State Significant Development Response to Submissions

Site 9, Sydney Olympic Park Mixed use Development

Submitted to NSW Department of Planning and Environment
On Behalf of Ecove Group Pty Ltd

October 2016 ■ 15719

Figure 2 – I Novotel Hotel colonnade, with height varying from 6.38 to 7.35 metres
 Source: Bates Smart

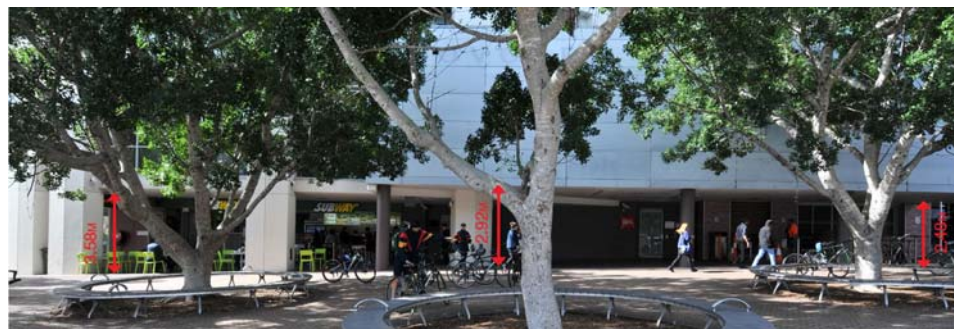
- The colonnade fronting the Pullman hotel varies in height from 2.86m to 4.06m;
- The colonnade fronting the Novotel varies in height from 2.48m to 3.58m; and
- The colonnade fronting the Ibis hotel varies in height from 6.38m to 7.53m and exposes upper floor tenancies to the colonnade below.

We believe that the heights of the existing 'single storey' colonnades are generally too low. Any areas less than around 3.5m high feel oppressive. We also believe that exposing an inactive upper level to the colonnade provides little benefit to the pedestrian experience of the colonnade.

Figure 4 – Proposed uses within the podium
 Source: Bates Smart

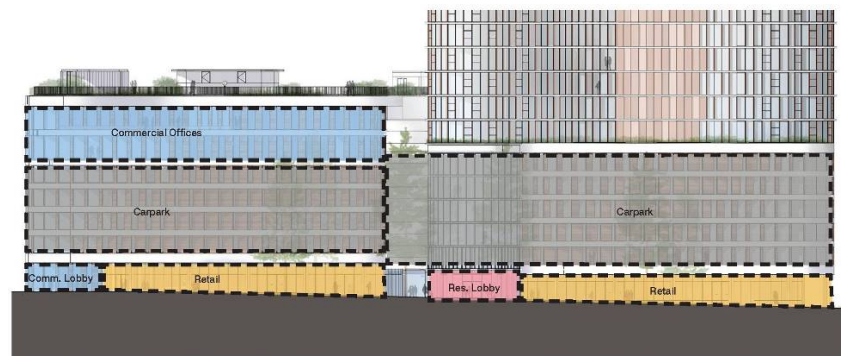
- That hard monochrome surface finishes are proliferating at SOP, and that even the proposed terra cotta finishes will not provide enough warmth and colour to alleviate the extensive use of glass and metal claddings
- The scale of the colonnade – single storey is too low for a development of this scale and for the Boulevard frontage

The podium has been designed as a response to the various uses as illustrated in **Figure 4**, and provides a single storey colonnade which relates to the active uses of the development at ground level. Detail sections are provided at **Figure 7** which demonstrate the following:

The two-storey height colonnade provides additional height to the ground level, however such a design exposes the upper level carpark facade directly to the colonnade. For this reason, it is proposed to raise the first floor level by 300mm to

Figure 10 – Amended ground floor plan
Source: Bates Smart

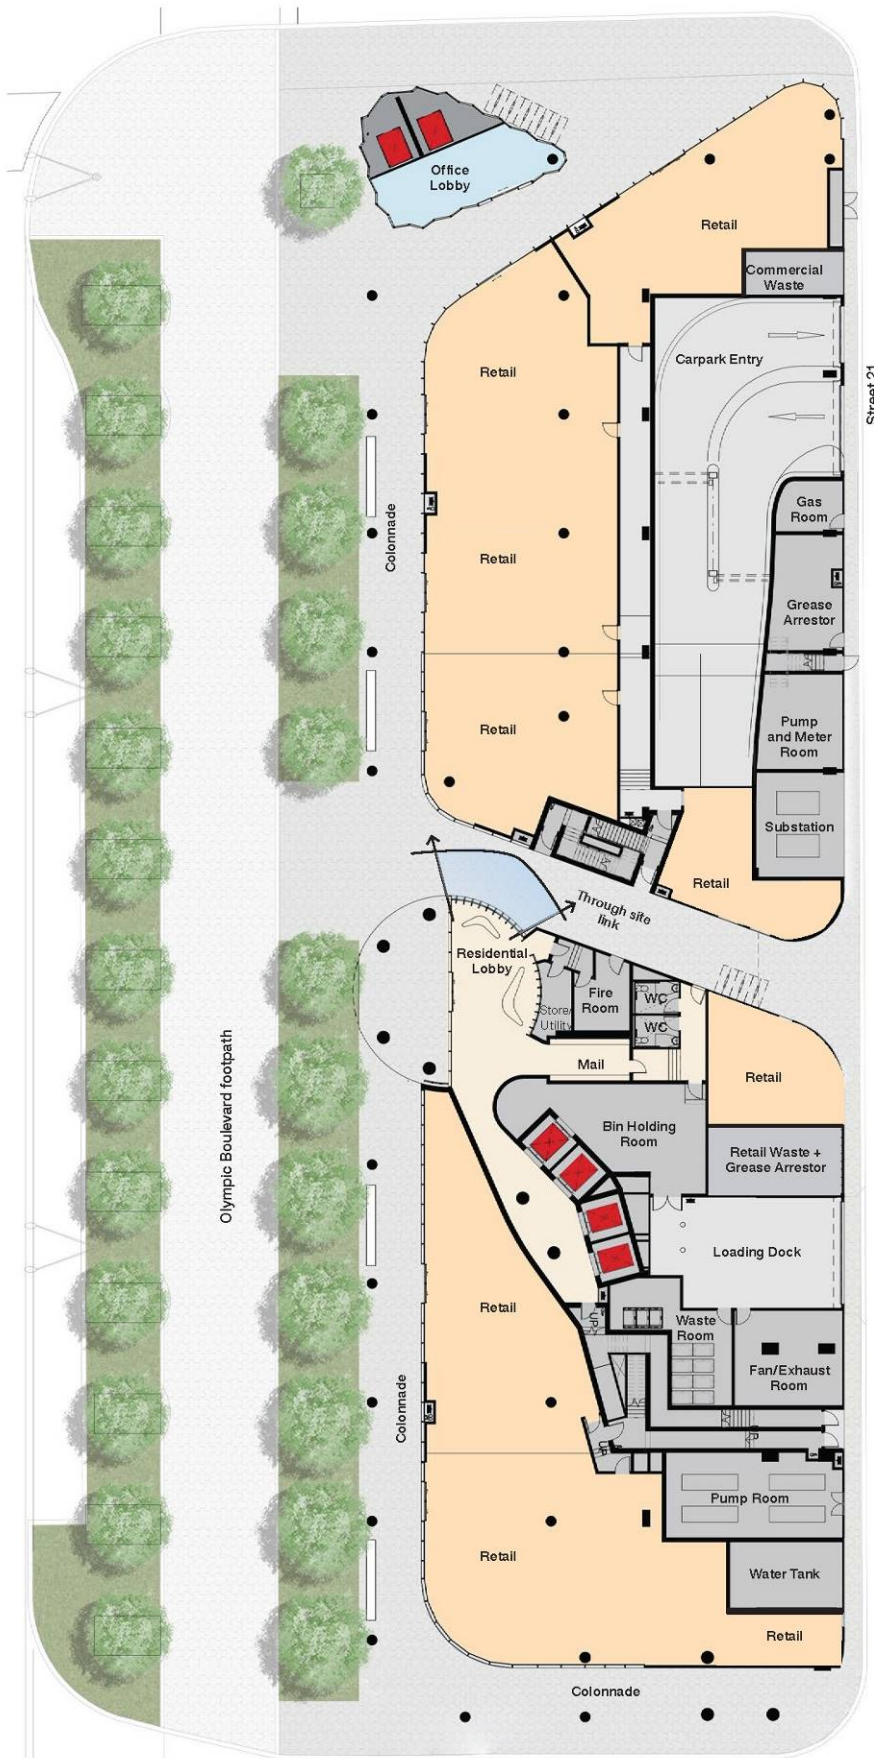
The proposed increase in the Ground Level floor to ceiling height to improve the proportions of the colonnade also results in an increased height for the through site link. The proposed width of the link has also been reviewed, and it is noted that the 5.4m proposed exceeds the width of 4.5m recommended by the Site 9 Development Guidelines. The proposed width will permit clear pedestrian thoroughfare, and it is noted that casual bicycle parking has been relocated out of the link. An indicative montage of the link, illustrating the proposed proportions, is provided at **Figure 8**.

Further to these measures, the design of the through site link and adjoining building has been refined to further increase activation (refer **Figure 9**). Additional retail / commercial tenancies are provided at the eastern corners of the site link, which will provide additional activation to the link. The bicycle storage and plant have been relocated. It is noted that the bicycle storage will be relocated to Level 9 of the tower, requiring the deletion of one apartment on this level.

Figure 21 – Illustration of building bulk shifted from southern elevation to the top of the building, ensuring all apartments enjoy excellent amenity
Source: *Bates Smart*

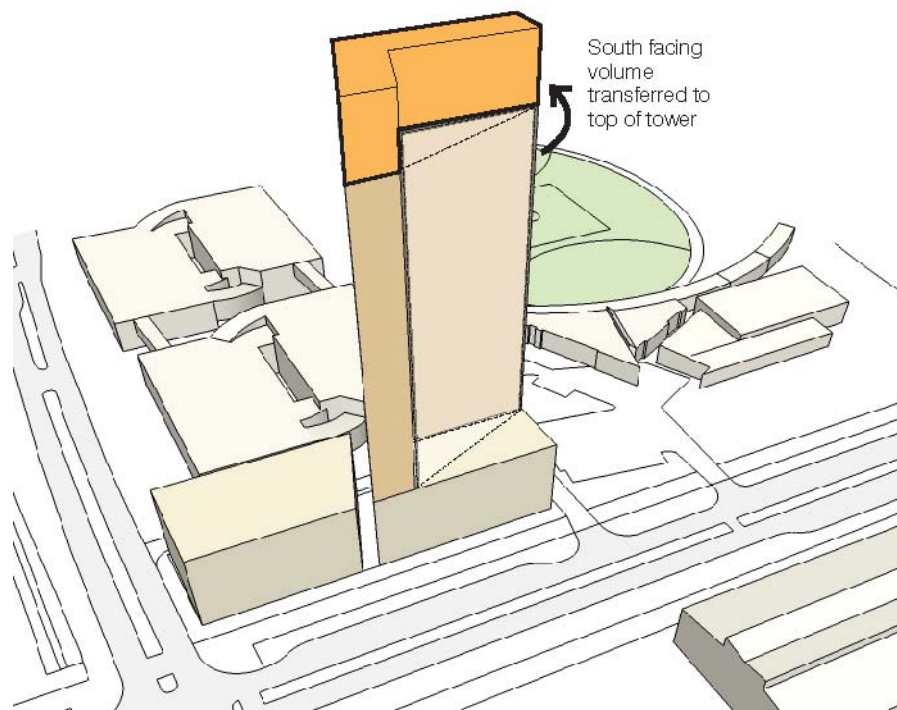
There are considered to be sufficient environmental planning grounds to justify contravention of the height of buildings development standards in this specific instance.

The proposed development has been specifically designed to achieve a high quality built form that is compatible with the envisaged built form of the locality. The tall, narrow tower form allows 100% of the proposed apartments to achieve a minimum of 2 hours of solar access on 21 June. This is an exceptional and rare achievement for a residential tower and was only achieved by sacrificing the dwelling yield efficiency of the floor plate. If the apartments were rearranged in a more traditional manner that locates units on the southern side of the core, the floor plate would be more efficient and the Apartment Design Guideline target of 70% solar access would likely still be achieved. However, the resultant building would not have the same architectural elegance and would not achieve a minimum of 2 hours of solar access to 100% of proposed apartments on 21 June. To achieve this high standard of design and amenity, the proponent is willing to forego the economic benefit resulting from a more efficient floor plate.
